Technical Service Bulletin

01 Cam adjuster, implausible signal - V6 FSI AVS

15 12 25 2031085/1 October 10, 2012.

Figure 1. Adjustment unit for valve lift system.

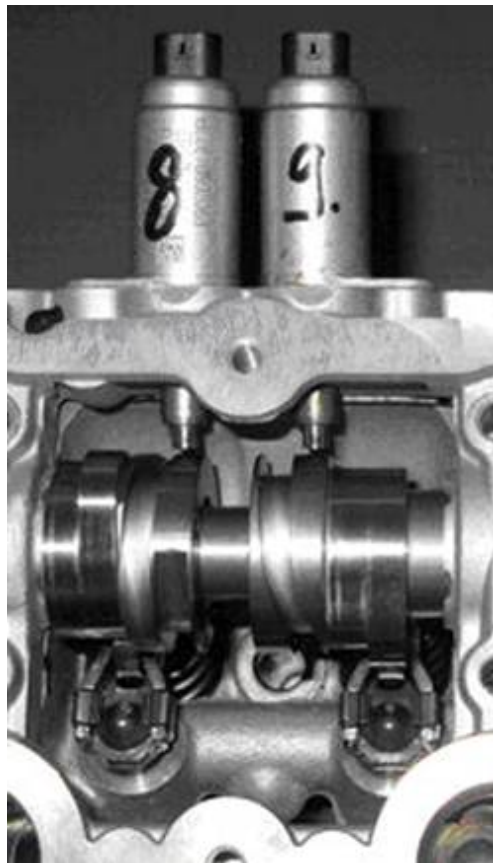
Check the distance of the pin tip of the cam actuator for valve lift system to the camshaft when it is not operated with a gauge. The measurement of the tip to the basic camshaft circle outside of the groove must be taken, see Figures 1-3 below.

If this measurement is 0.9mm, the actuator **06E103697J** must be installed.

The actuator **06E103697J** must only be used, if the measurement is 0.9mm or bigger.
